Meeting: 6/18/2025
Applicant: Logan Higgins
Owner: Scott & Bernadette West

Location: 32 Market Square **Parcel ID** 94 L E 044 094LE045
District: Market Square H
Zoning: DK (Downtown Knoxville)
Description: Vernacular Commercial, c.1890

Level II Construction of Addition or Outbuilding

6-H-25-HZ
APPLICATION FOR CERTIFICATE OF APPROPRIATENESS

VISIBILITY VIEWS

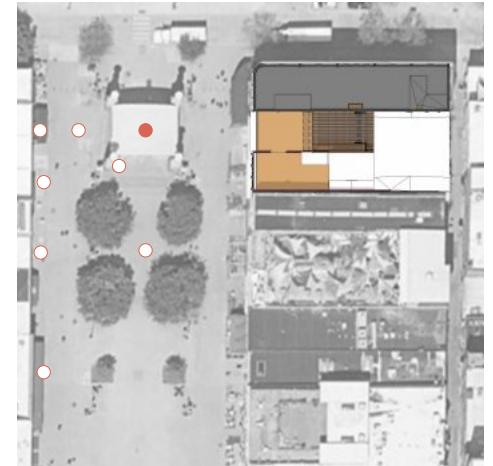
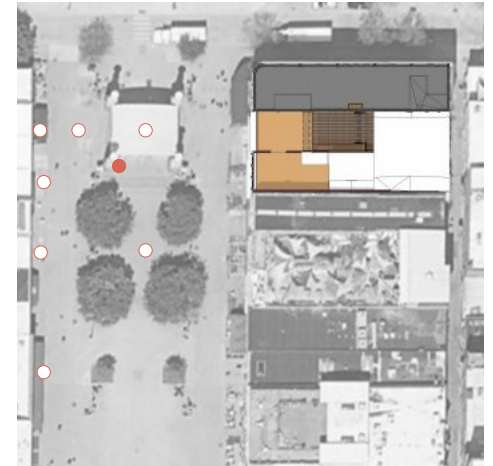
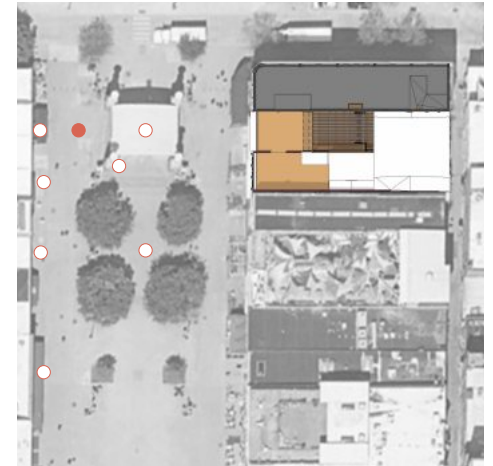
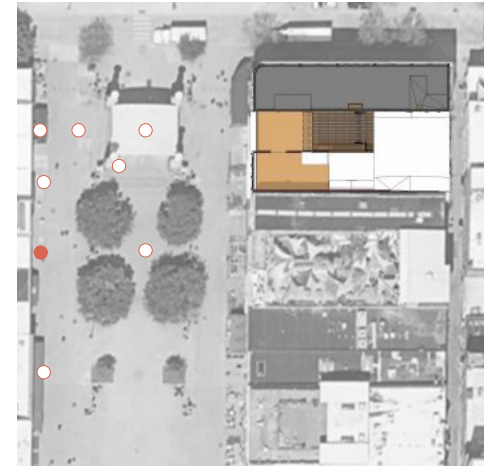
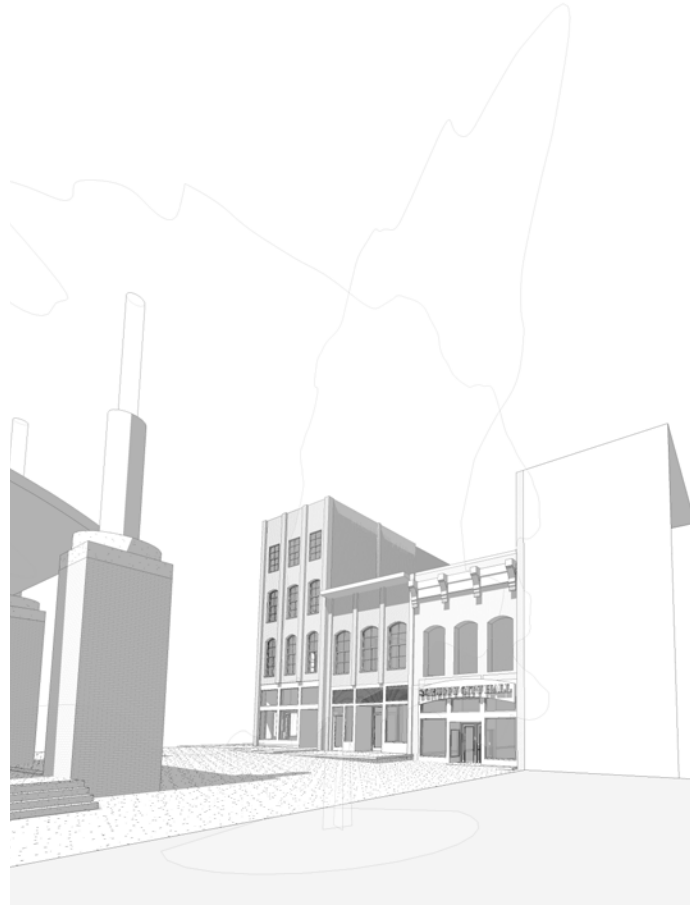
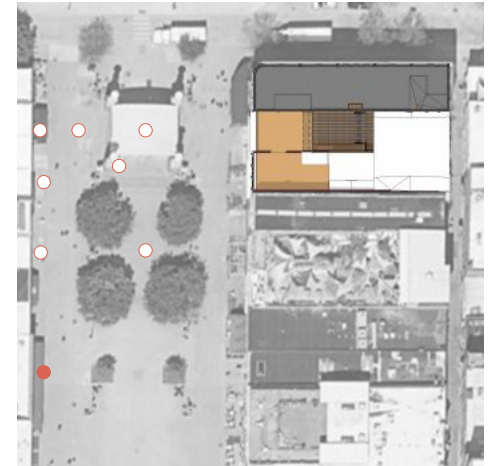
5. Based on the provided 3-D renderings and line of sight drawings, the proposed rooftop structures will be visible from the right-of-way. Several renderings use the Market Square pavilion and tree plantings as a method of obscuring the addition. The rooflines will be recessed from the Market Square-facing parapet by approximately 30’. It is unclear if the two-story, full-width barrel vault roofline will be visible from points in Market Square. The timber flat-roof pavilion structure and the half-round roofline with an enclosed (with glass) massing will be visible from the right-of-way.

Staff recommends postponement of 6-F-25-HZ to allow the applicant to propose a rooftop addition that is recessed further towards the rear of the building (aiming to be less visible or not visible at all from the right-of-way), with a roofline and overall design that is more compatible with the character of the buildings and the district.
